C-E Power Systems
Combustion Engineering, Inc.
Route 21-A
Hematite, Missouri 63047

NIS/81/854

License SNM-33
Docket 70-36

Enclosed are eight copies of Drawing D-5008-2023, which were omitted from our application dated June 19, 1981 for dry powder storage on conveyors and mezzanine storage of agglomerated press feed.

PROPOSED LAYOUT OF BLDG. 255-1, 1ST FLOOR & MEZZANINE

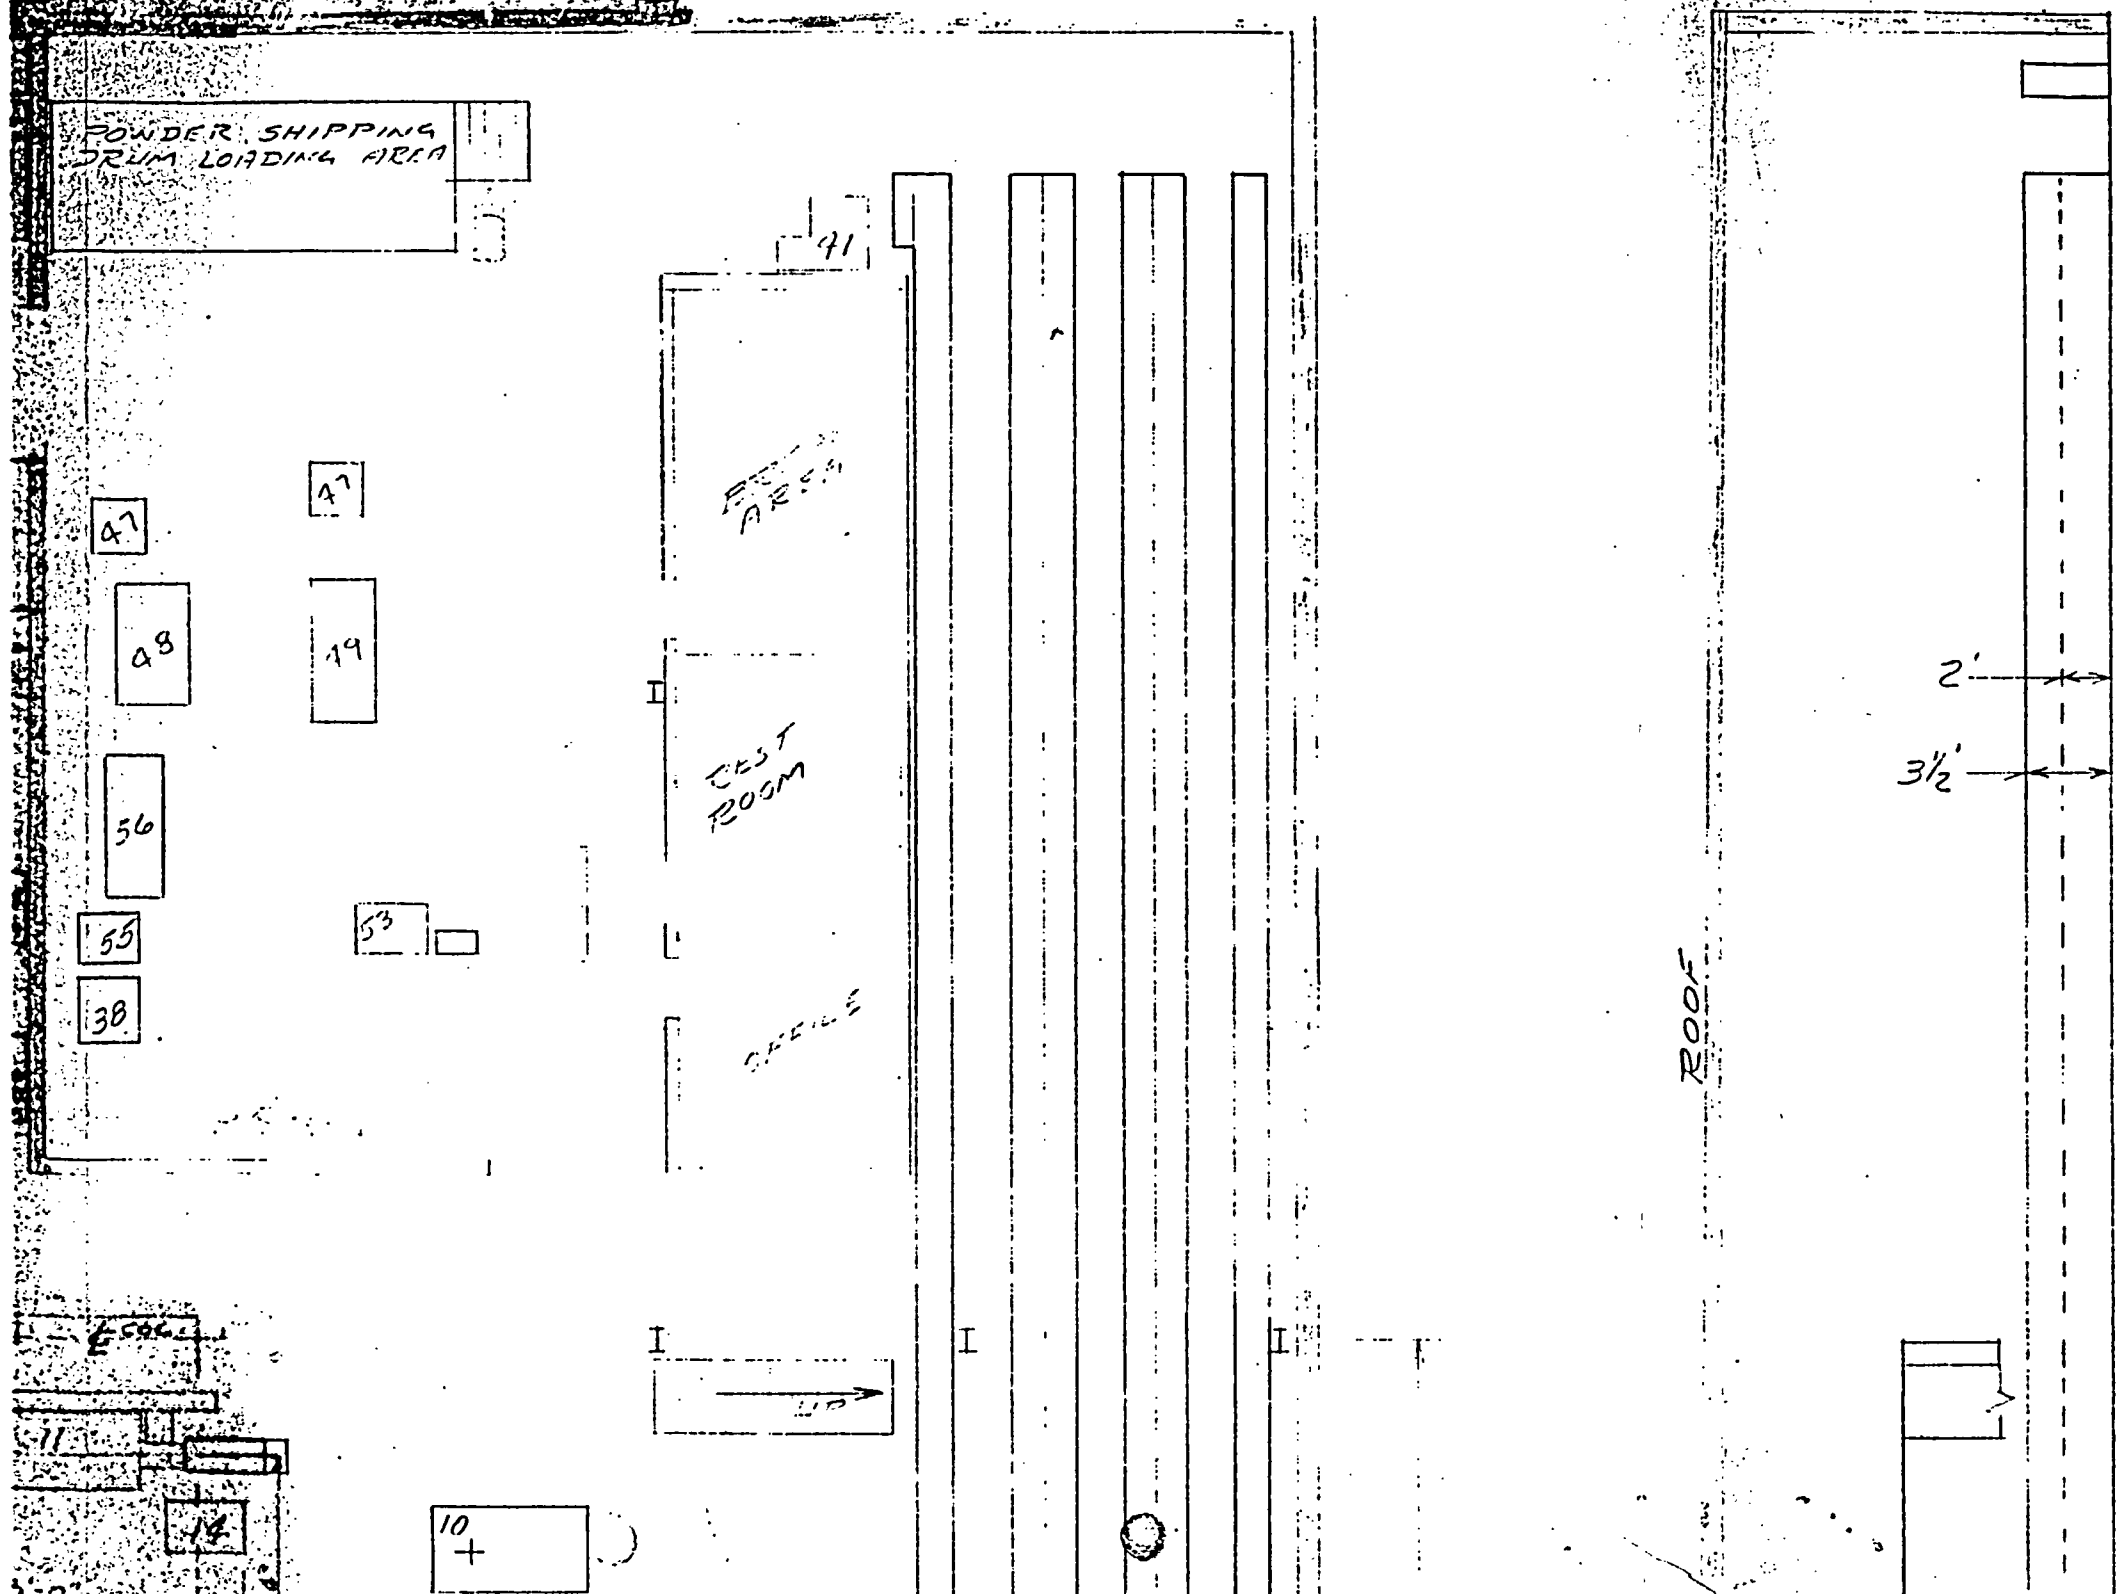
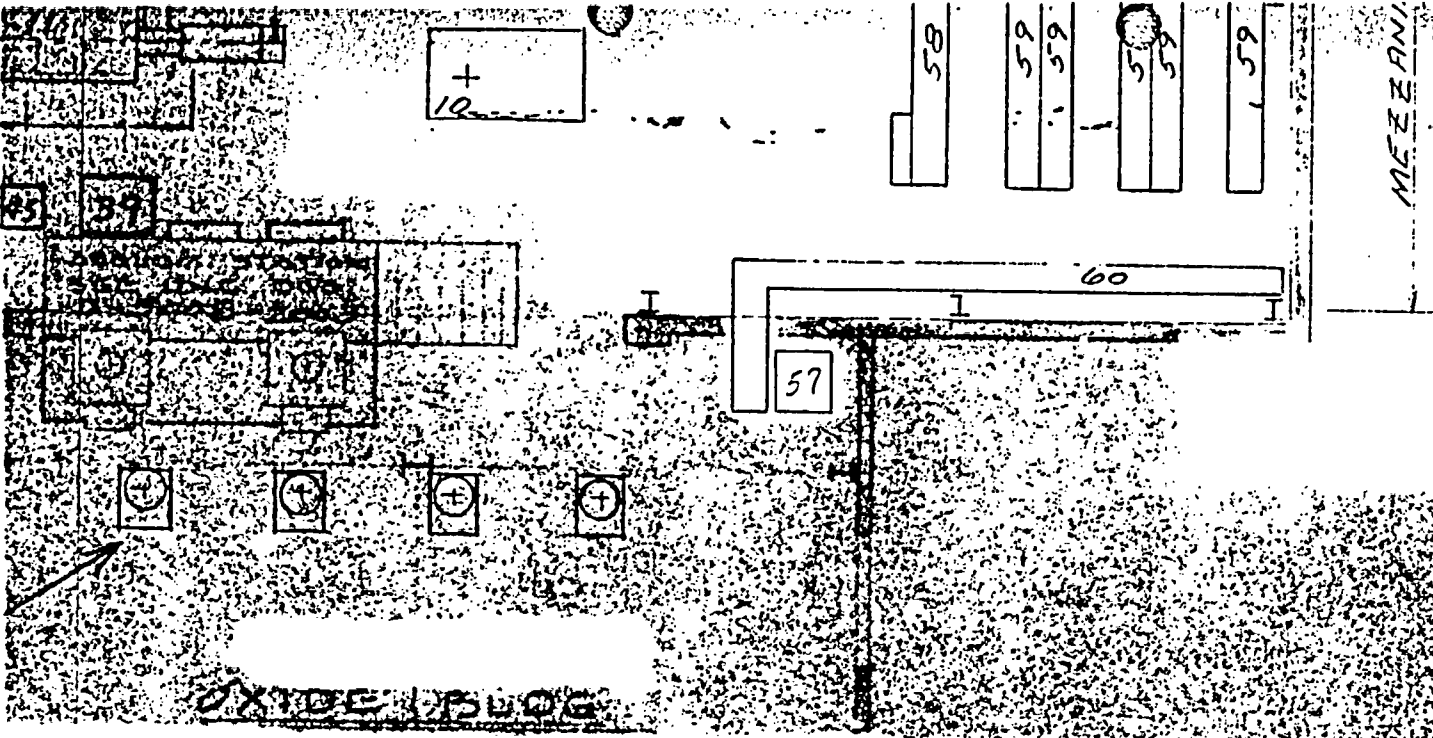
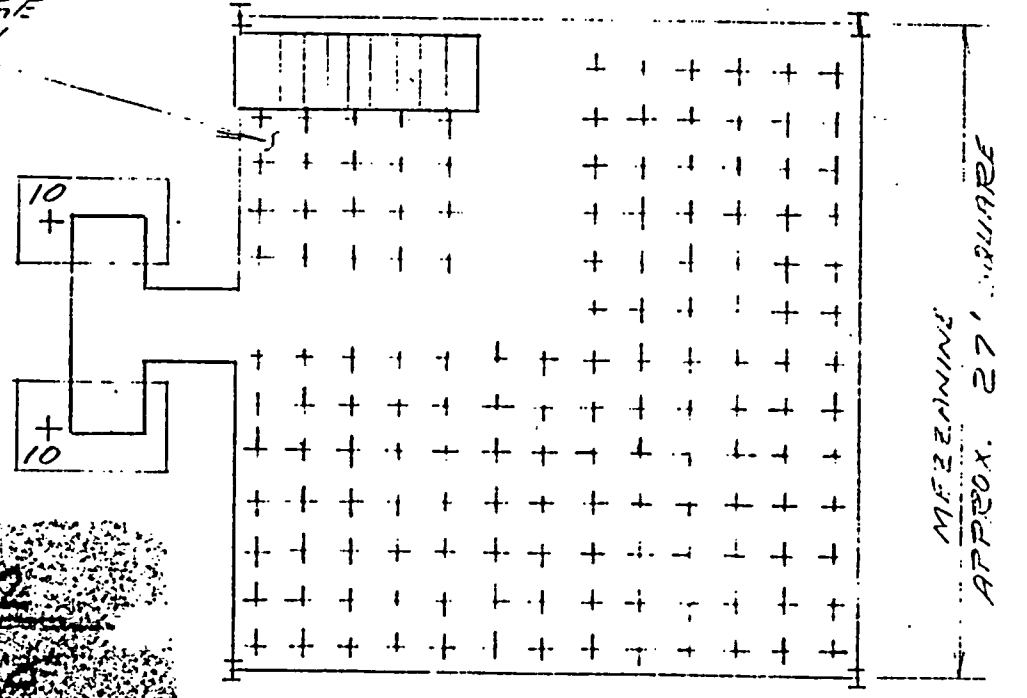
The sealed cans of dry UO_2 product are then transferred to one of 5 roller conveyors on the north side of Building #255 as shown in Items 58, 59 and 60 of Drawing D-5008-2023, dated 2/5/81. The entire building is above the 100 year flood level as determined by the U. S. Army Corps of Engineers in their Special Study for Joachim Creek, dated March 1980. Even if flooding were possible, the 30 Kg weight of the cans containing high density UO_2 would prevent them from floating and being moved. Building #255 is not sprinklered and firefighting would be by dry chemical means. Thus, criticality safety is assured through moderation control (\leq 4.1% enriched UO_2 cannot be made critical without moderation).
